RE: Response to TCEQ NOD 3 Addendum – CCR105  
Luminant Generation Company LLC – Tatum, Rusk County  
Industrial Solid Waste Registration No. 31277  
EPA Identification No. TXD000821306  
Tracking No. 27220868; RN102583093/CN603256413

Table 1 - NOD Summary and Response  
Registration No. CCR105 - Luminant Generation Company LLC  
Application Deficiencies - Addendum to NOD 3

RE: Response to TCEQ NOD 3 Addendum – CCR Registration No. CCR105  
Martin Lake Steam Electric Station - Rusk and Panola Counties, Texas  
(SWR 31277; RN102583093; CN603256413; EPA ID No. TXD000821306)

### Figure 3 A1 AREA LANDFILL CROSS SECTION LOCATION MAP

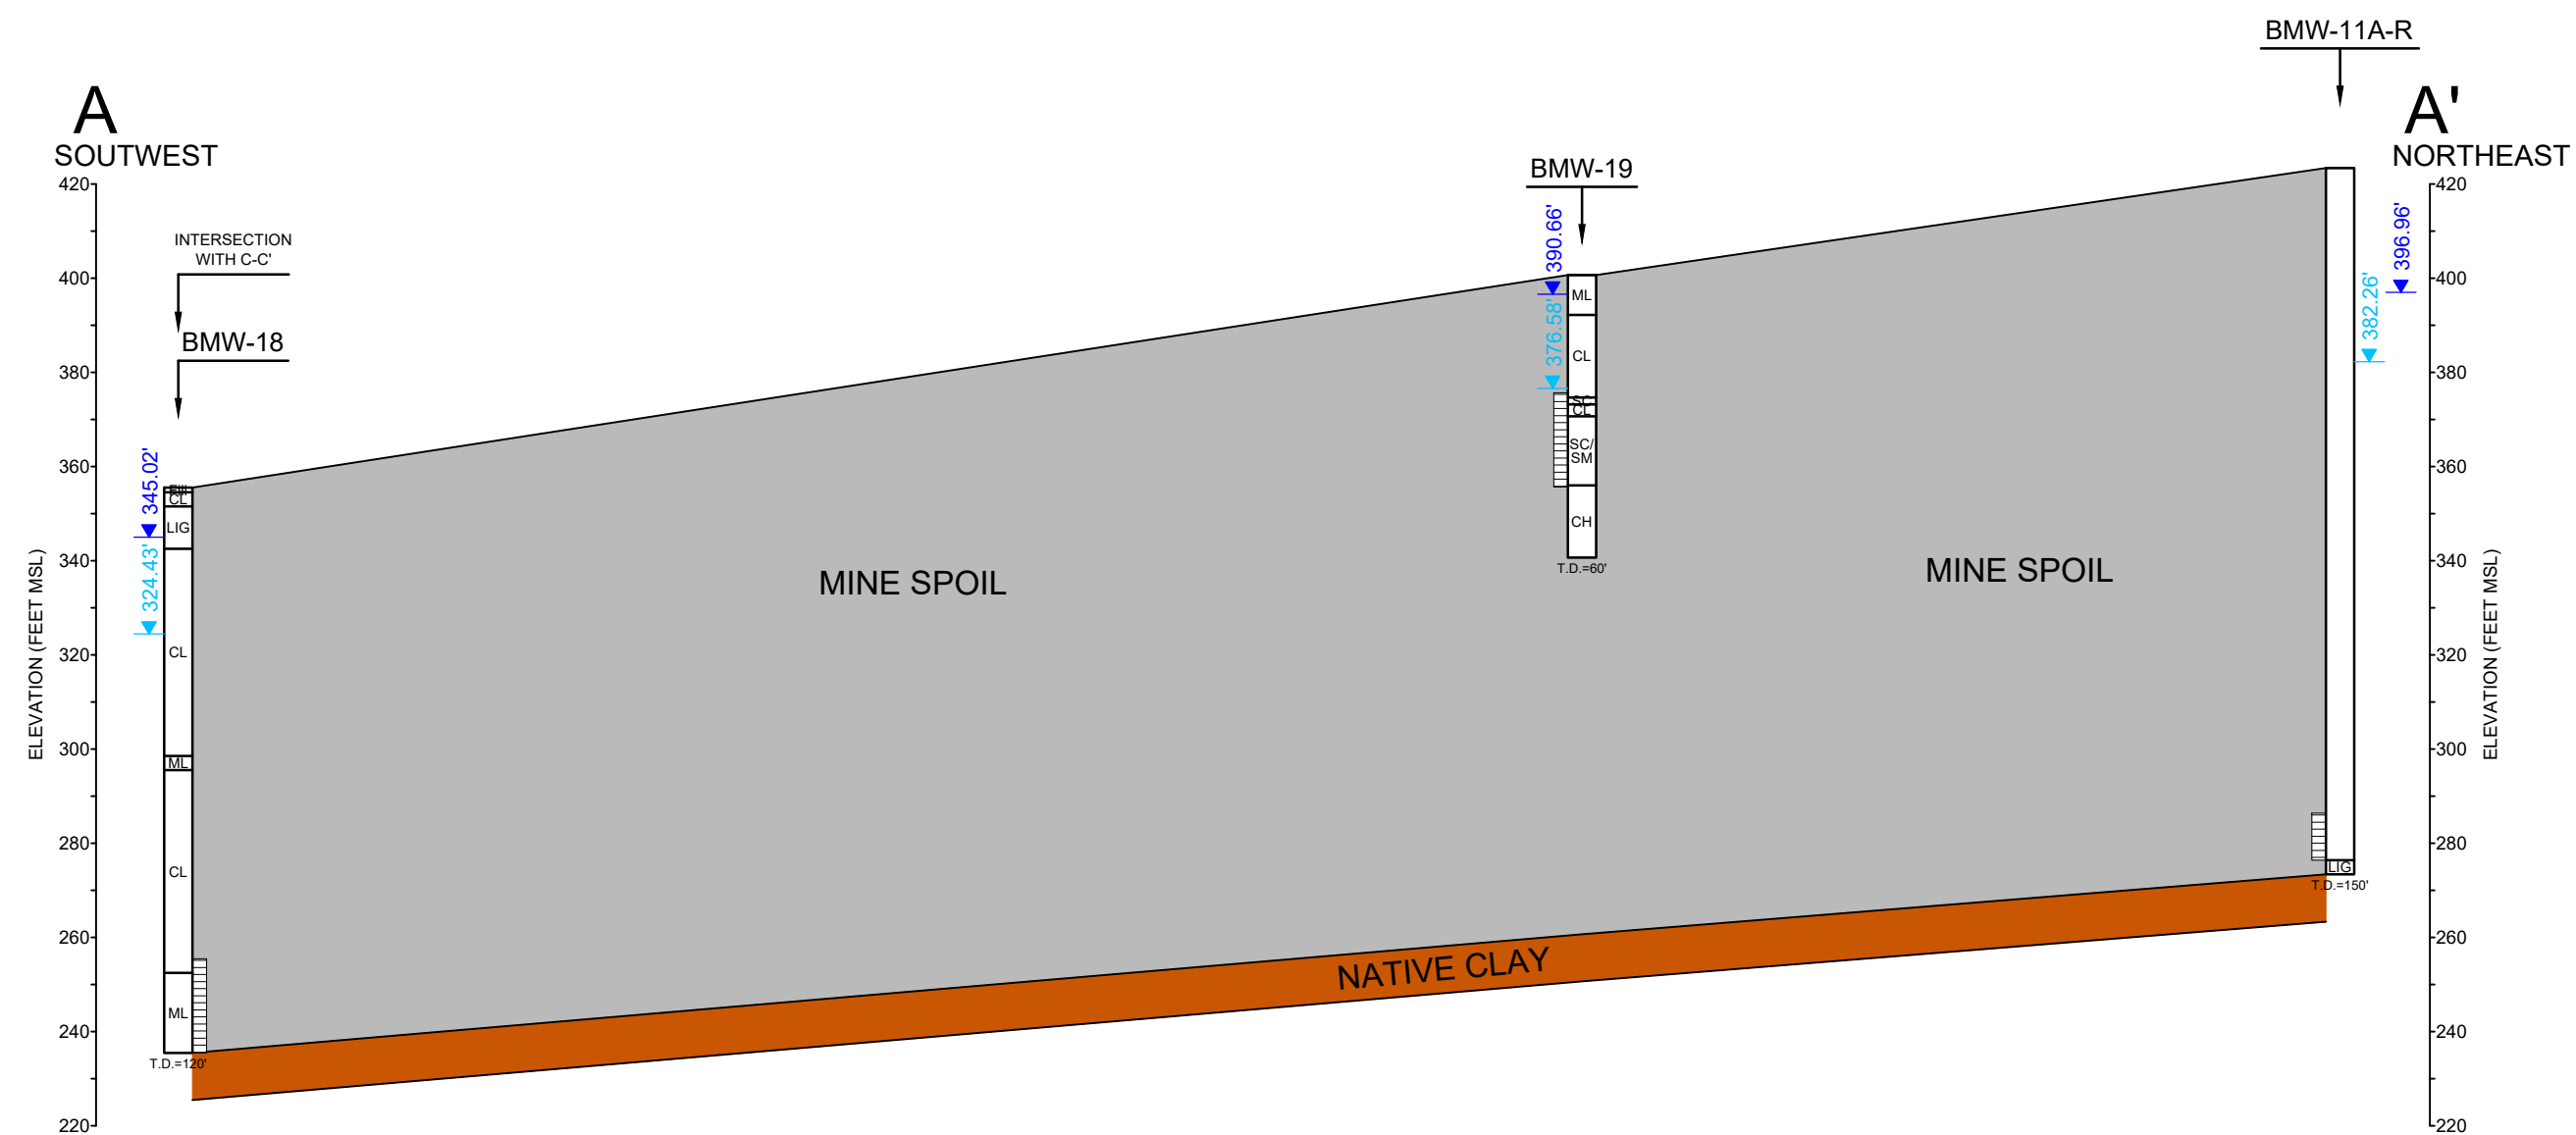
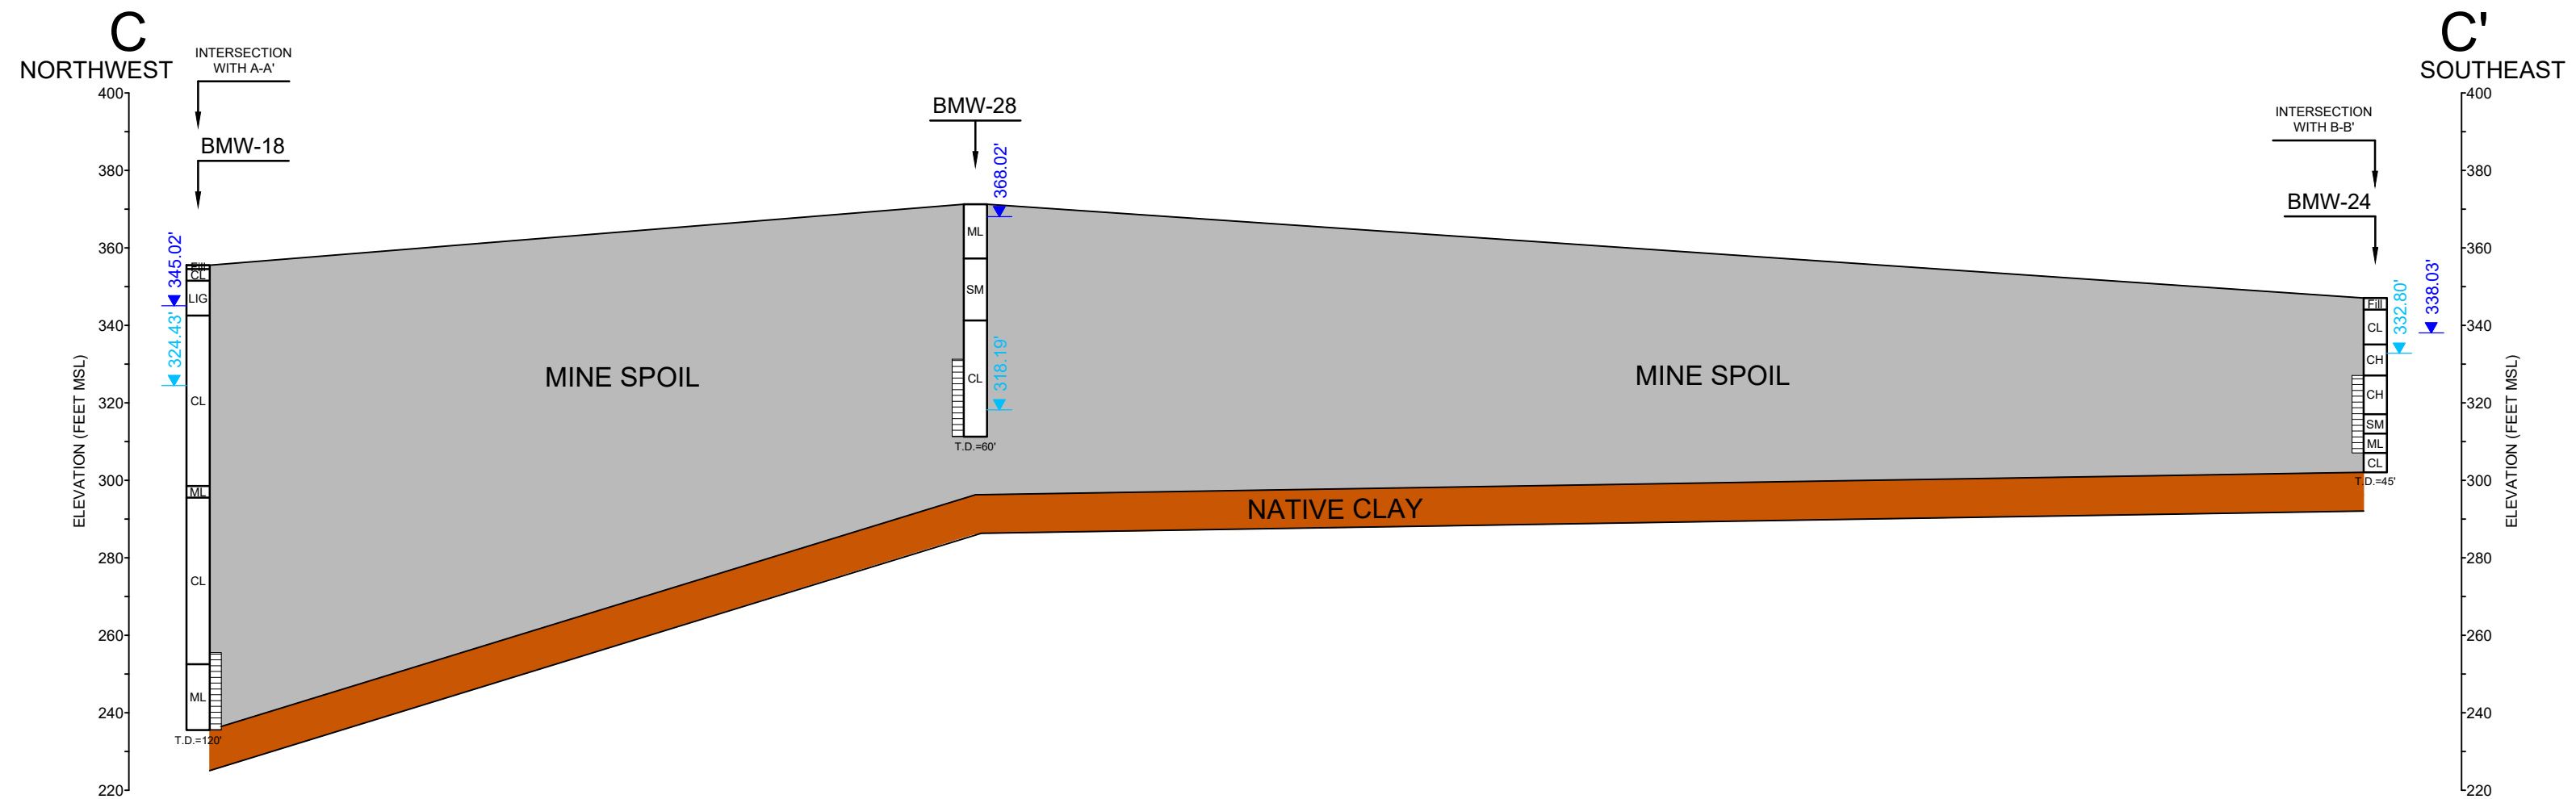
*[A1 Landfill:] Provide North-South and East-West geological cross sections across the landfill down to the bedrock and beyond the boundary of the mine spoils showing the local subsurface geology in the vicinity of the landfill along with the projected nearest wells to the cross sections. Also, provide the maximum and minimum historical groundwater levels on the monitoring wells in the cross sections.*

**Response:** The requested A1 Area Landfill cross sections are provided in Attachment 2.

| GEOLOGIC CROSS SECTION B-B'                               |         |                 |             |

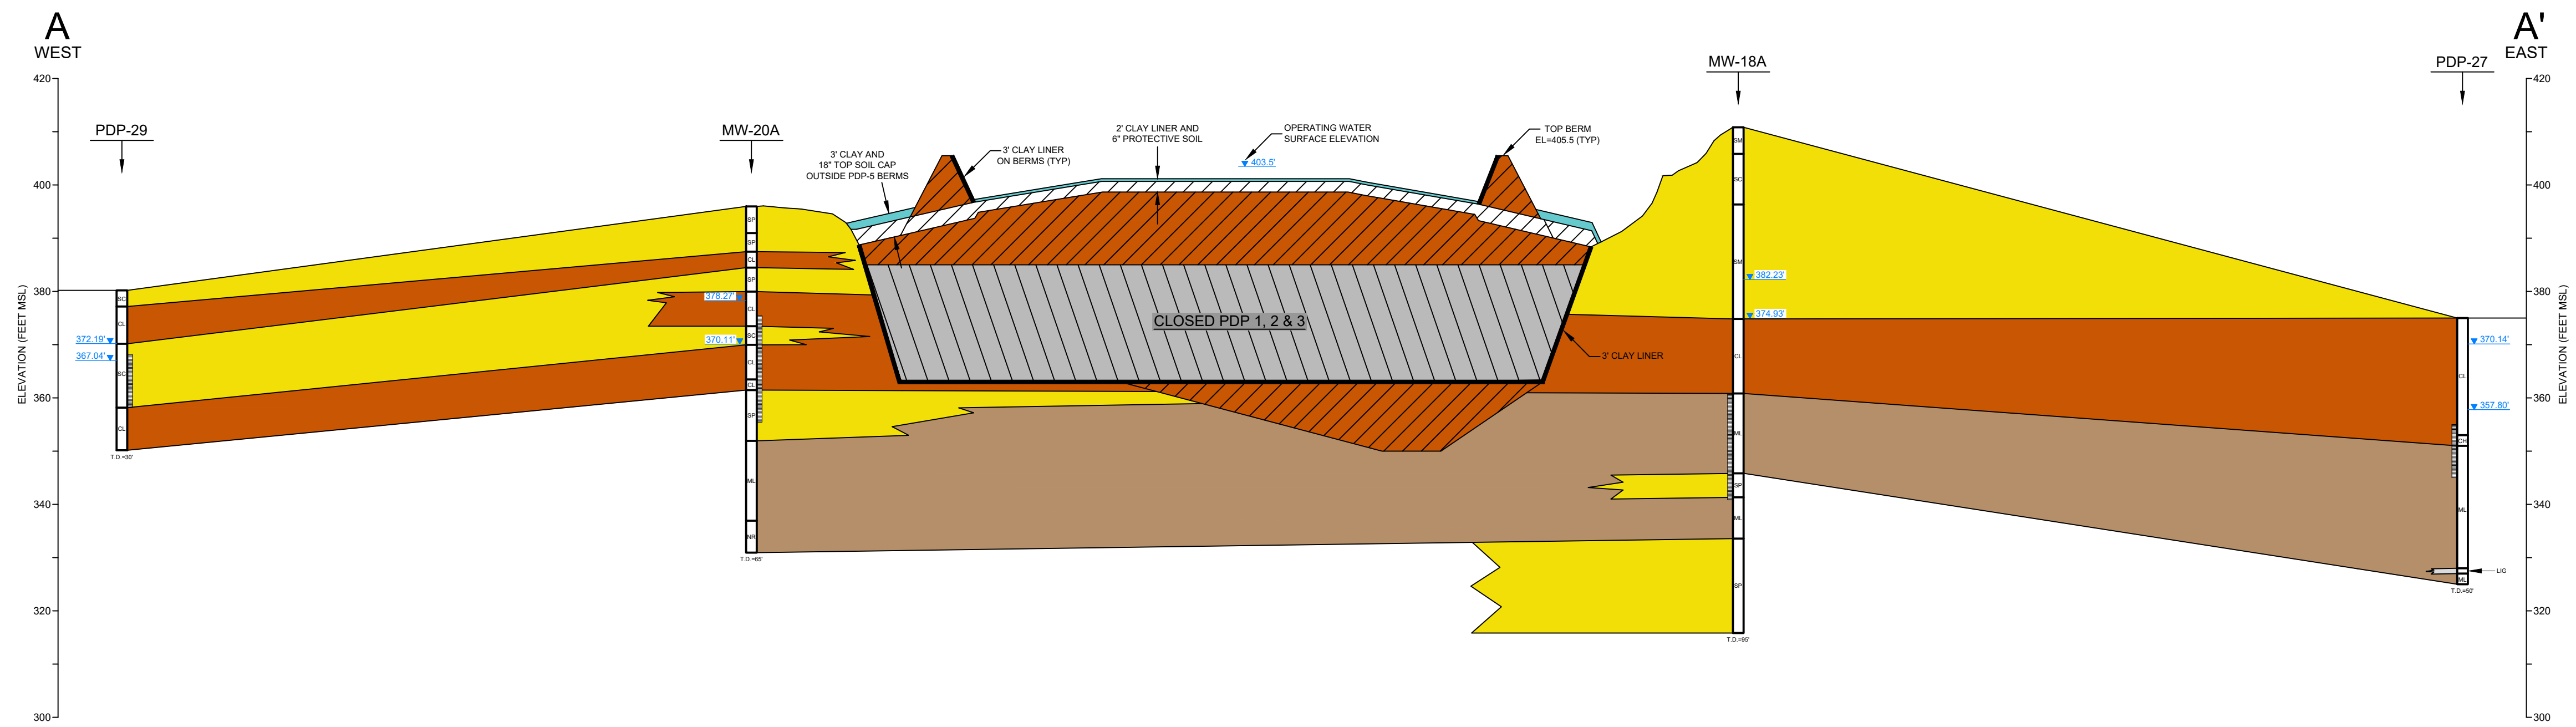
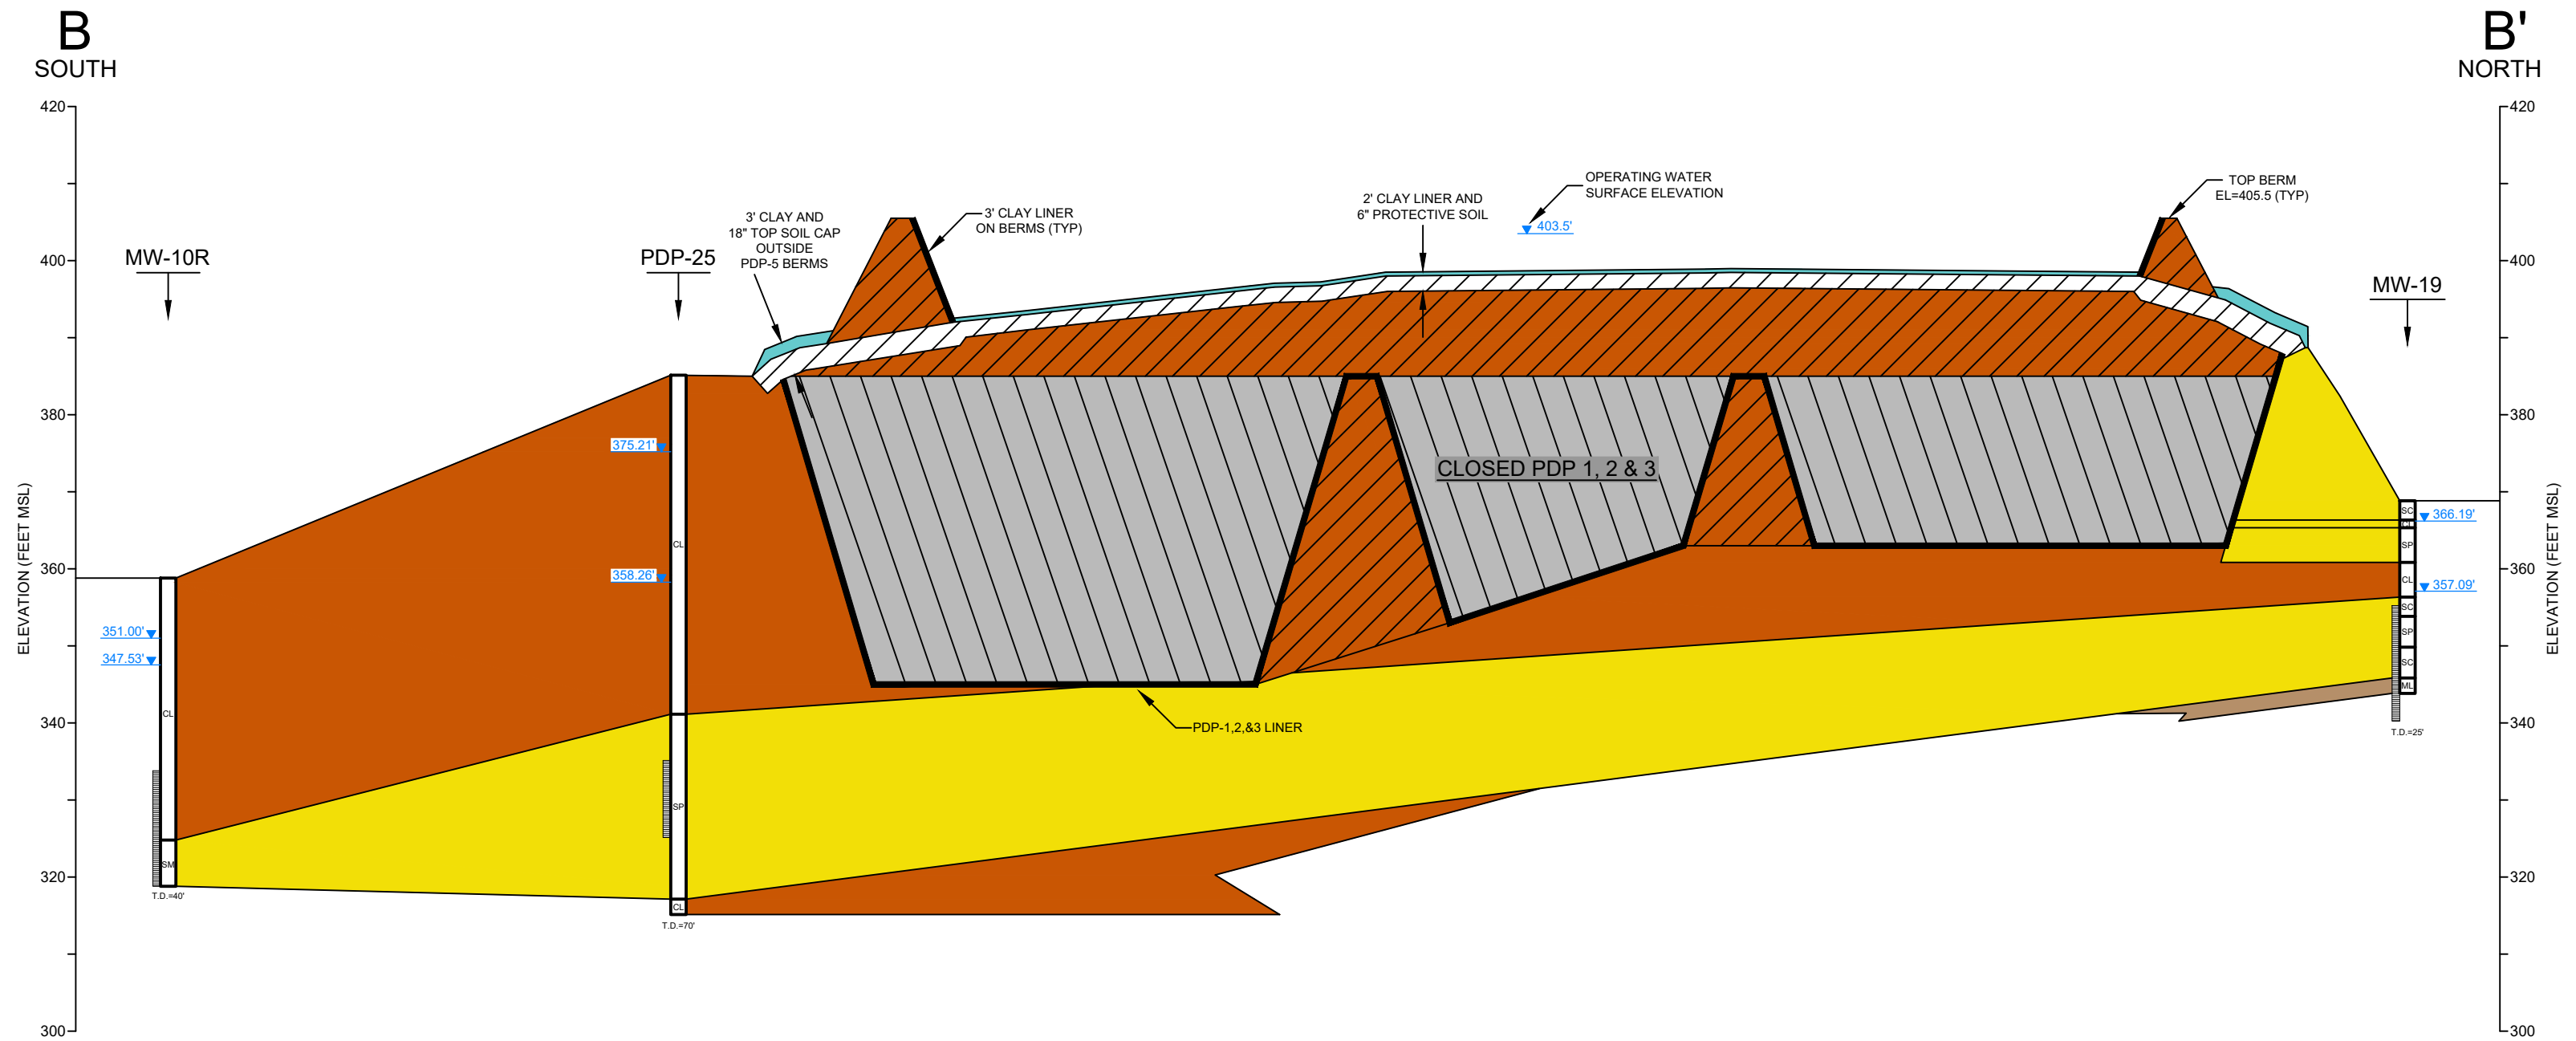
*Update the geological cross sections across the PDP-5 Surface Impoundment (and the closed PDPs-1, 2 and 3) (A-A' and B-B') to include other nearby wells to extend the subsurface geology beyond the unit boundary. Also include the historical highest and lowest groundwater levels at each additional well added to the cross section.*
